TOWN OF LITTLE ELM
PLANNING & ZONING COMMISSION

April 6, 2023

Project	PRELIMINARY PLAT/ Elementary School No. 27 (PP-23-00402)
P&Z Hearing	04/06/2023
Council Hearing	N/A
Size	Approximately 13.166 acres
Current Zoning	Planned Development (Residential Base)
Proposed Use	Community Facility (CF)
Existing Use	Vacant
Future Land Use Plan Designation	Low Density Residential
Applicant	Seth Kelly, RLK Engineering, Inc.
Owner	Brandon Boyter, Denton ISD
Strategic Goal

Date: February 17, 2023
Plan Review #: 1
Received: February 1, 2023
Plan Date: January 31, 2023
Development: DISD Spiritas Elementary School - No. 27

POST-DEVELOPMENT DRAINAGE CRITERIA

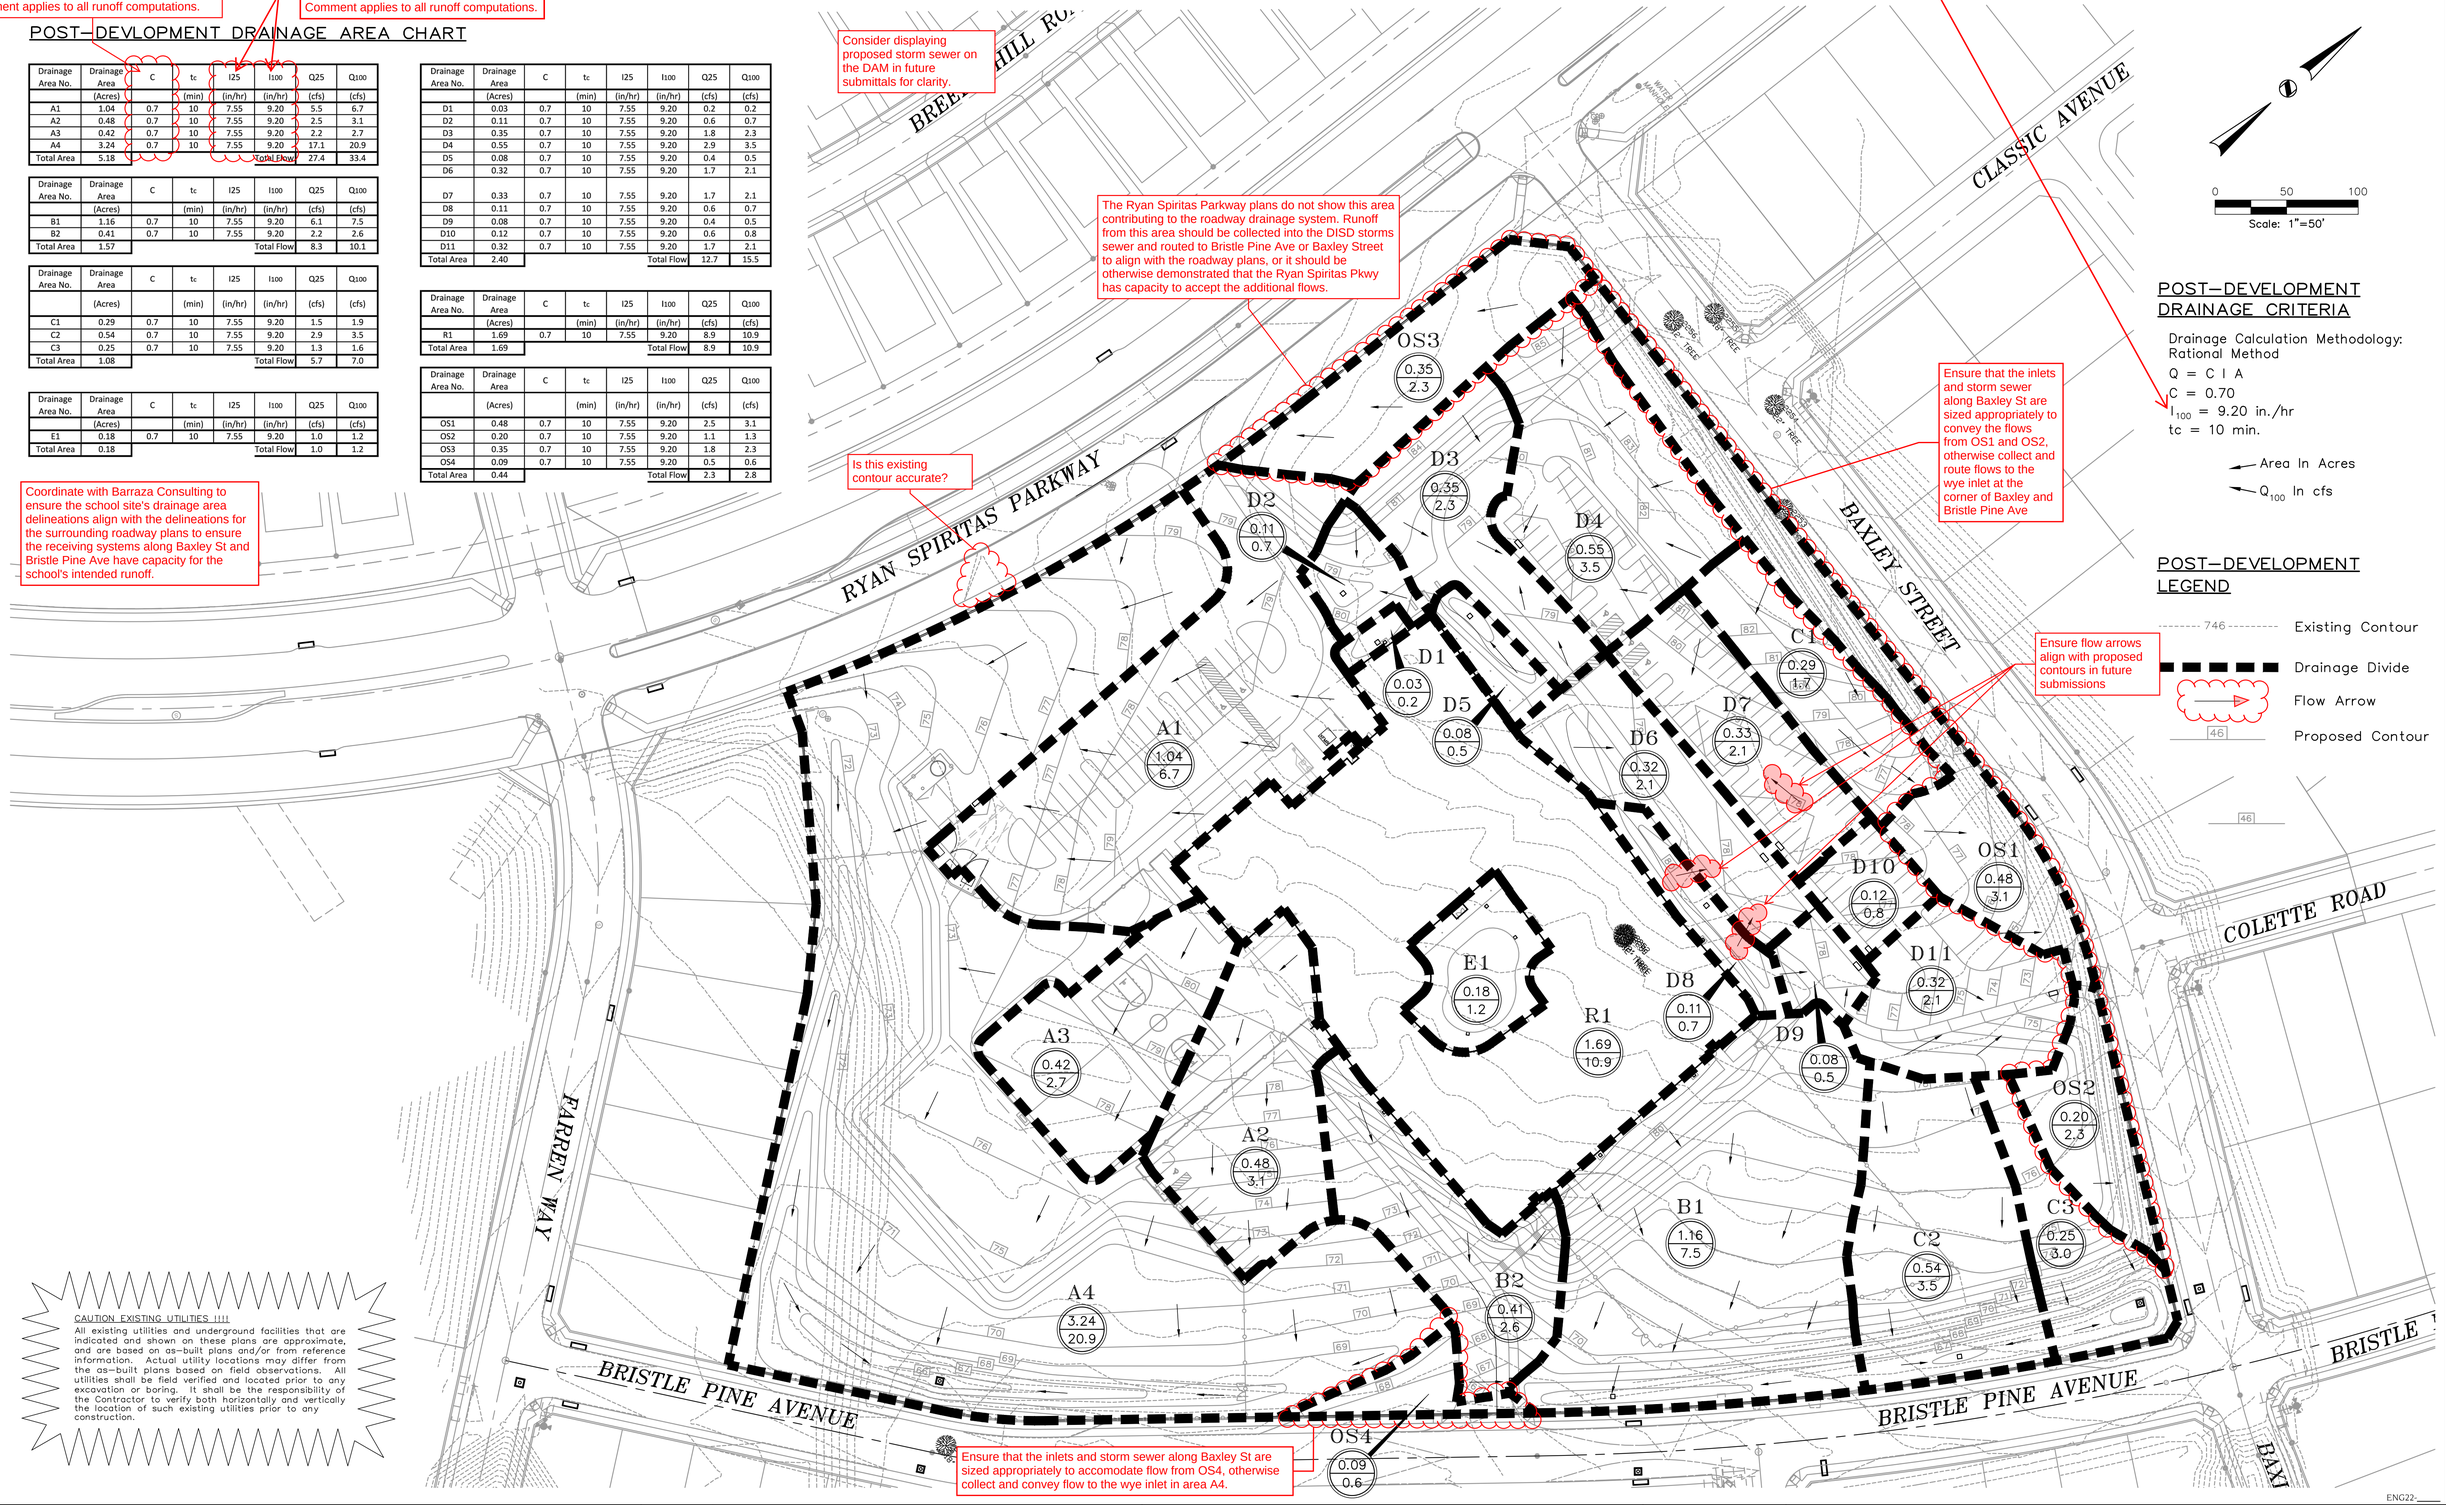
Ensure flow arrows align with proposed contours in future submissions

Ensure that the inlets and storm sewer along Baxley St are sized appropriately to accomodate flow from OS4, otherwise collect and convey flow to the wye inlet in area A4.

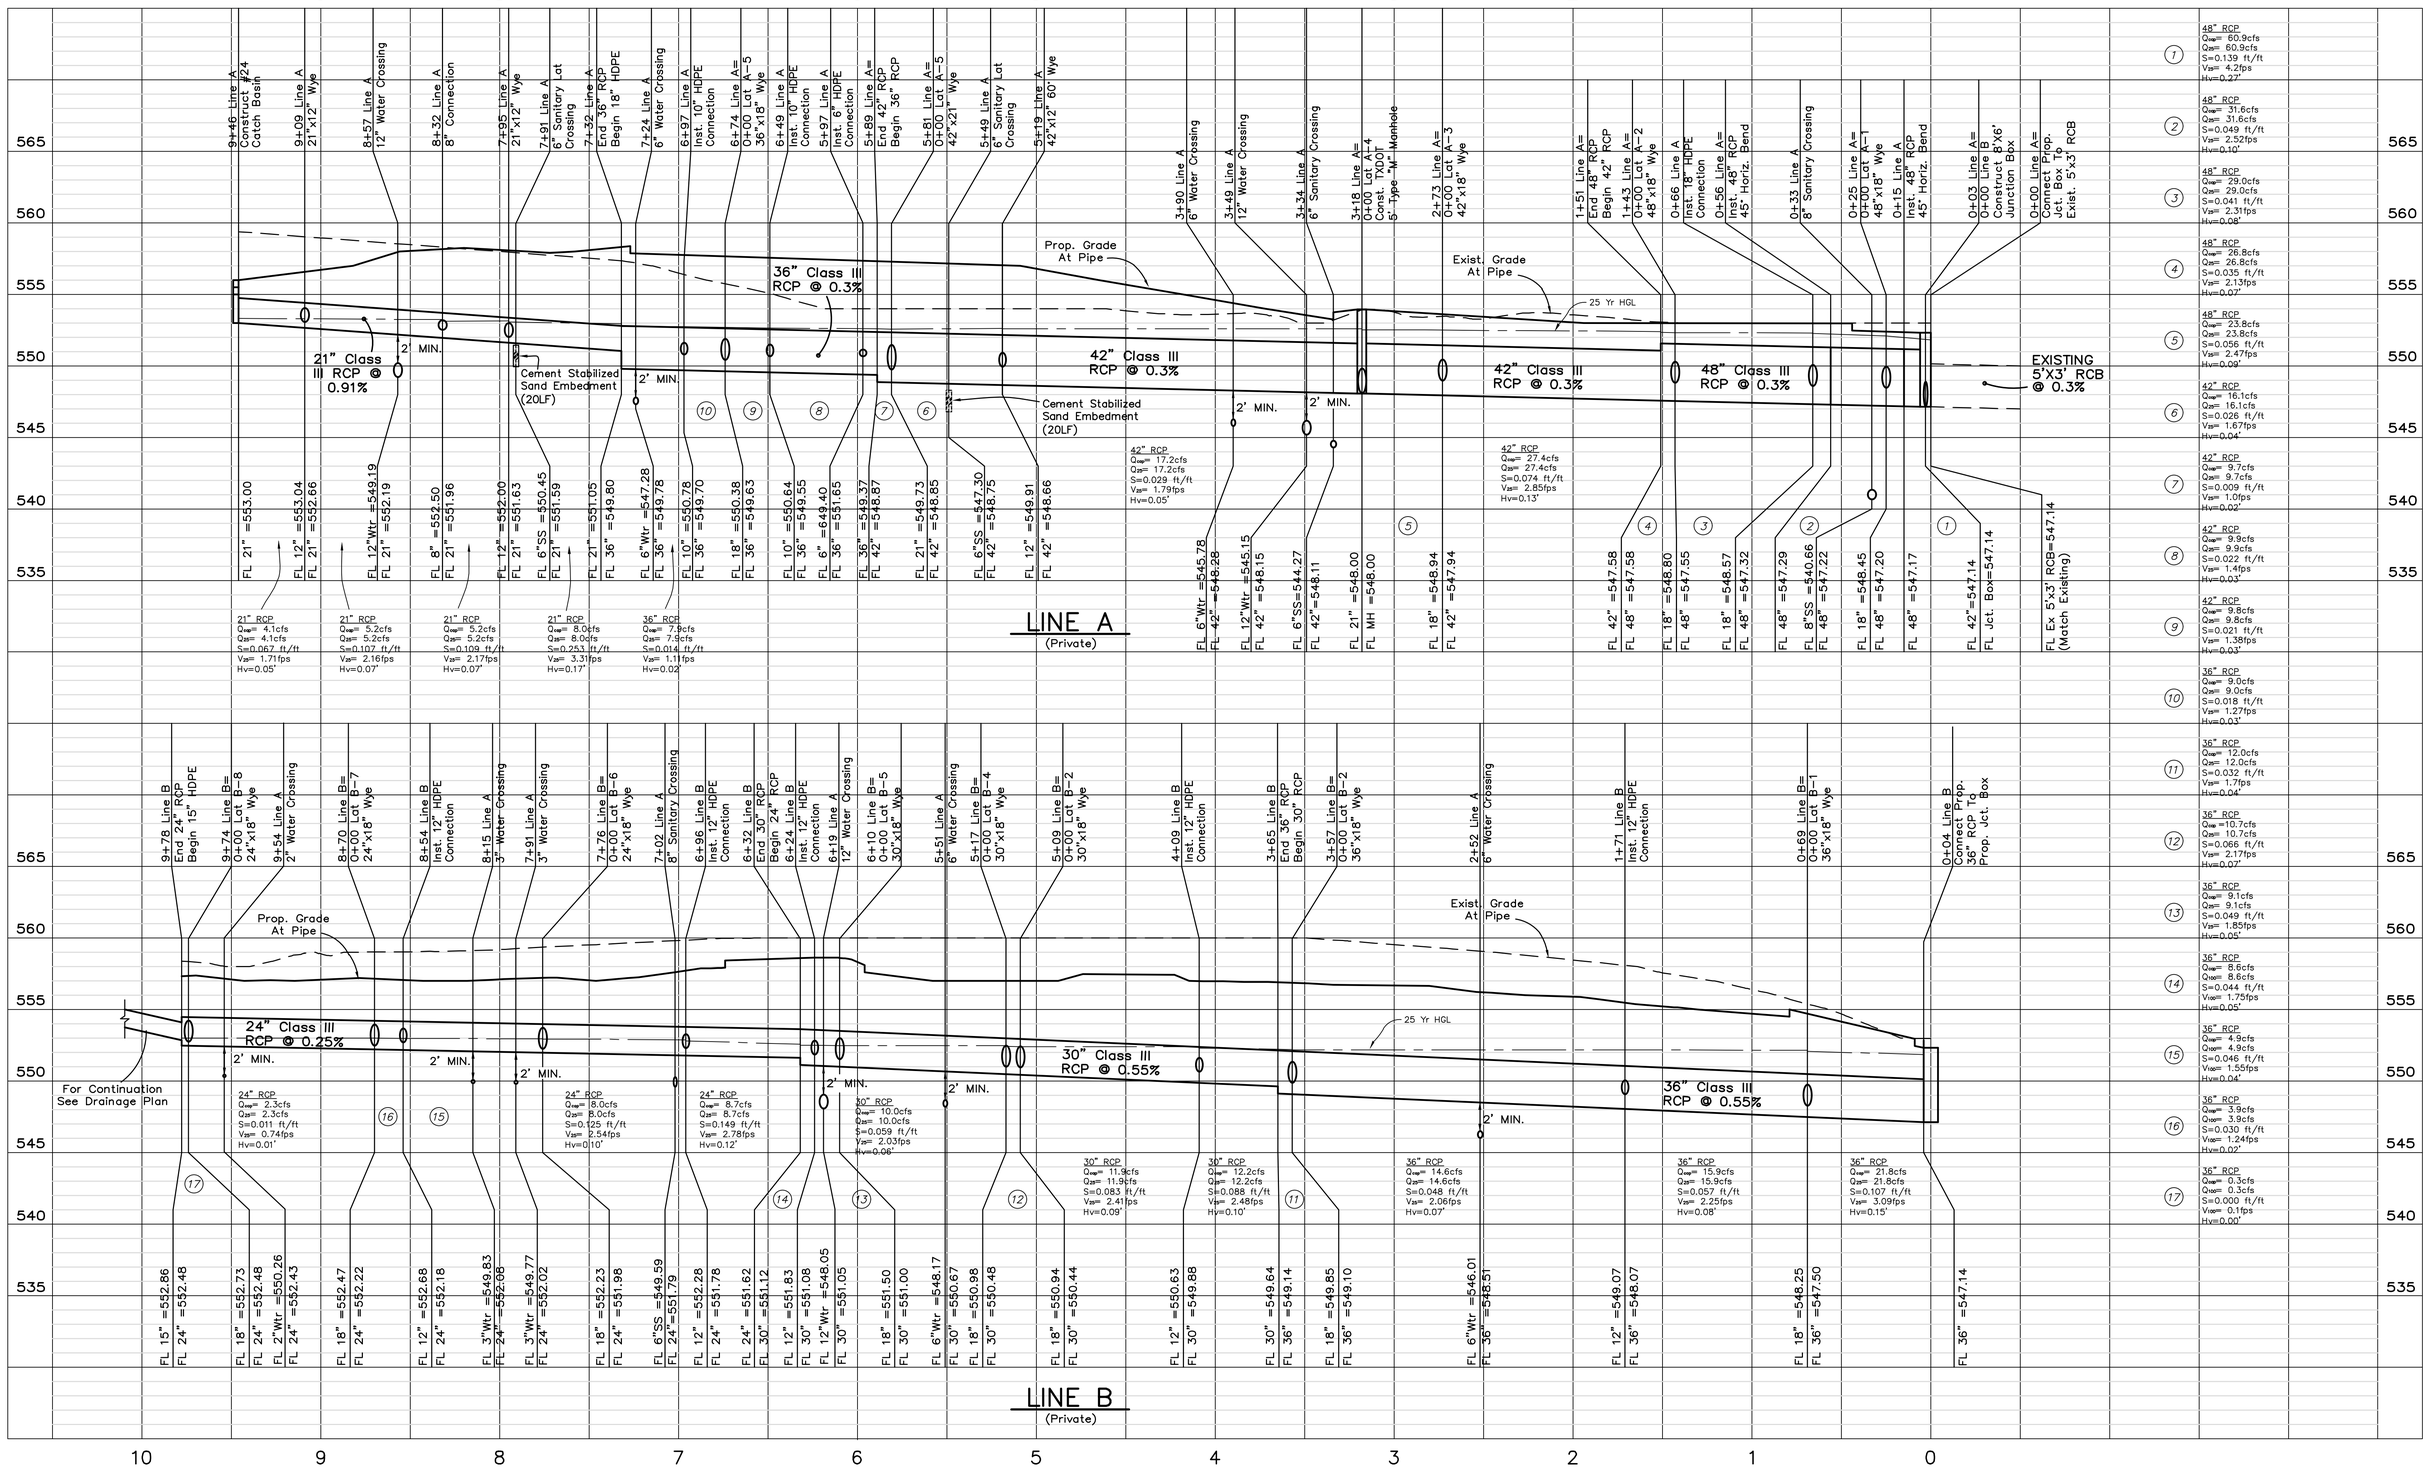
Pipe calcs were not reviewed as part of preliminary plat review. Comment from 1st review indicated to show pipe calcs on profiles when plans are submitted for SDV permitting review.

SANITARY SEWER LINE SS1

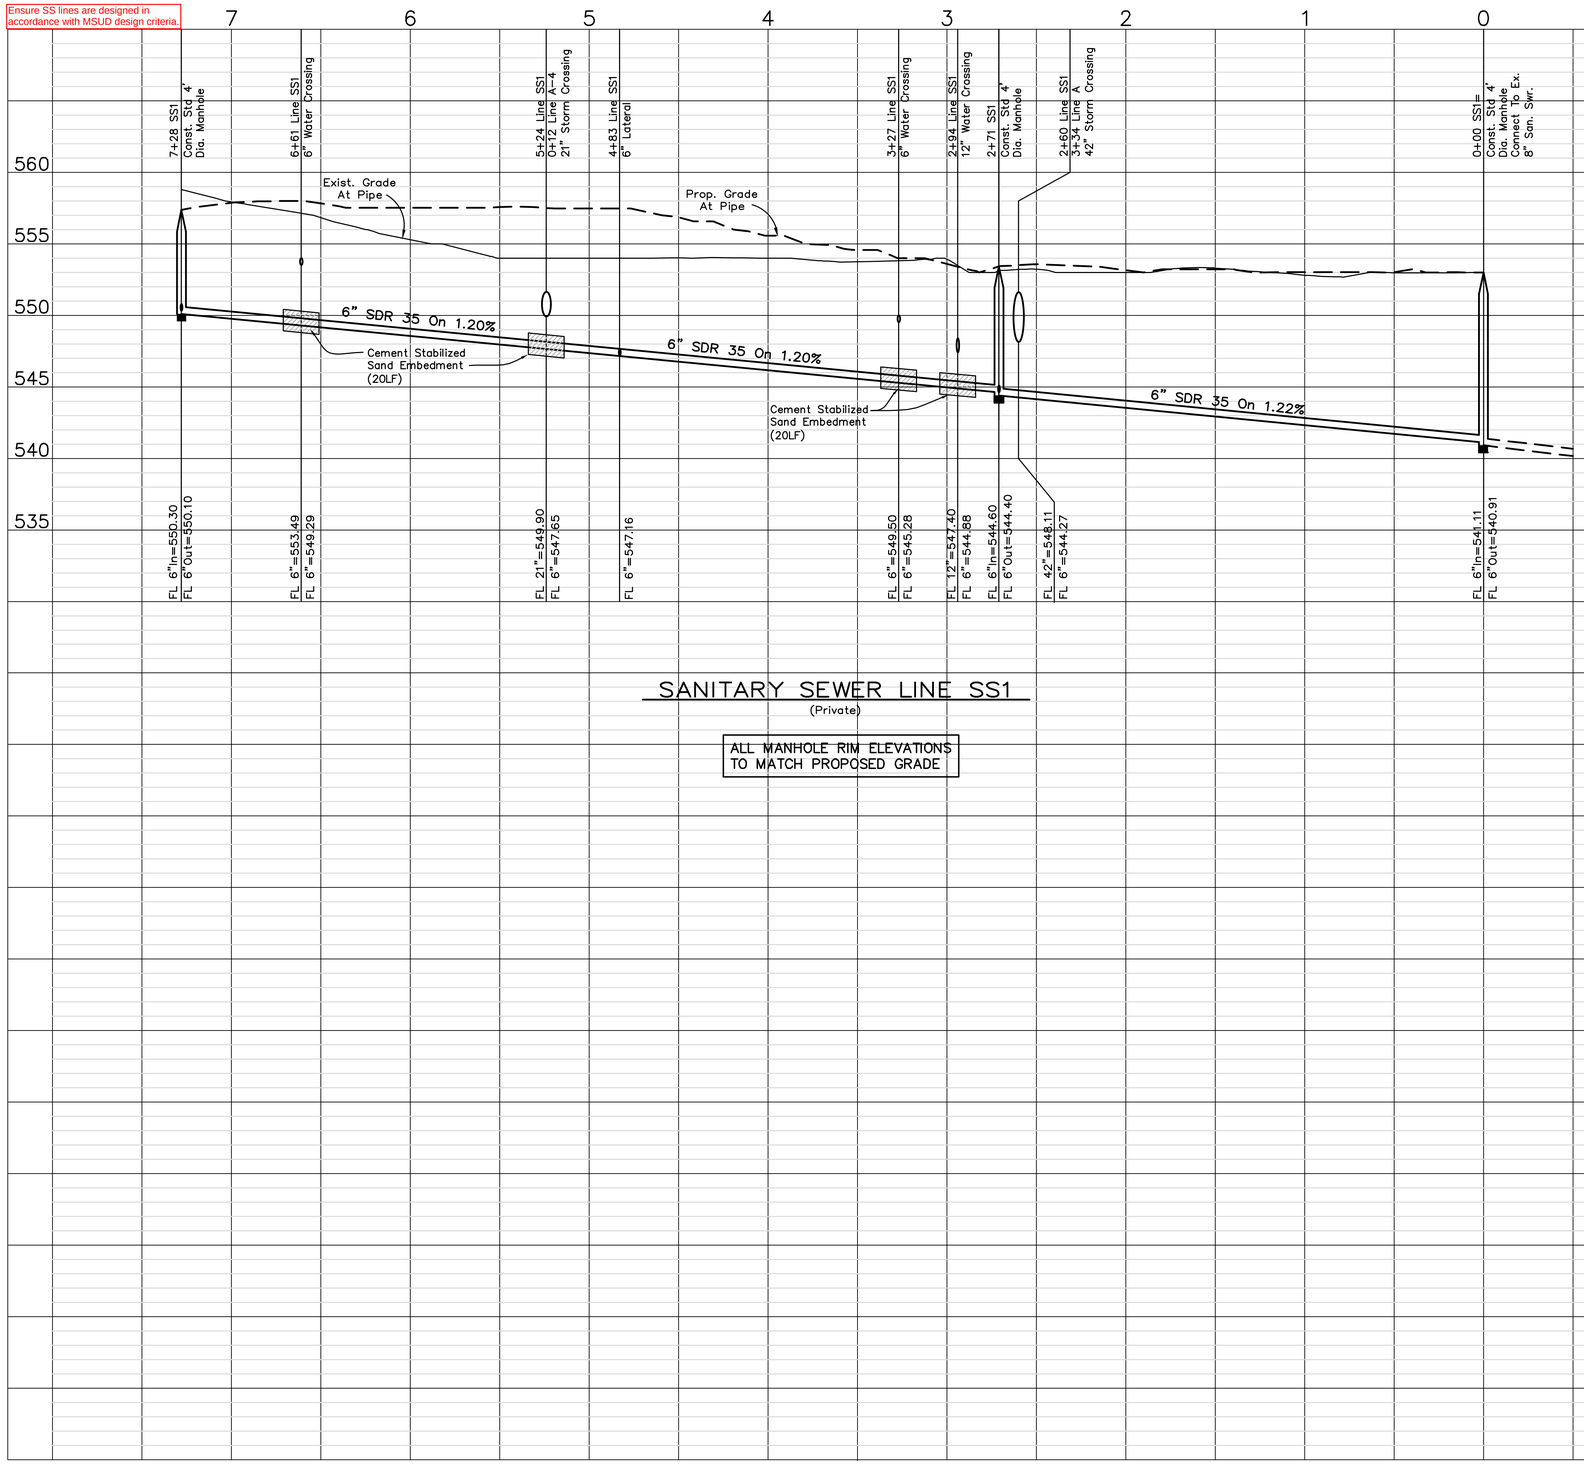
Ensure SS lines are designed in accordance with MSUD design criteria.

ACCESSIBLE STRIPING DETAIL

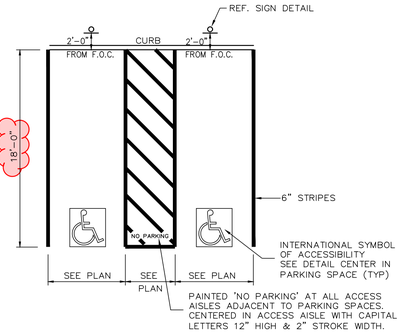
Town ordinance requires parking spaces to be 20' x 10'. Ensure meets Town ordinance or DA.
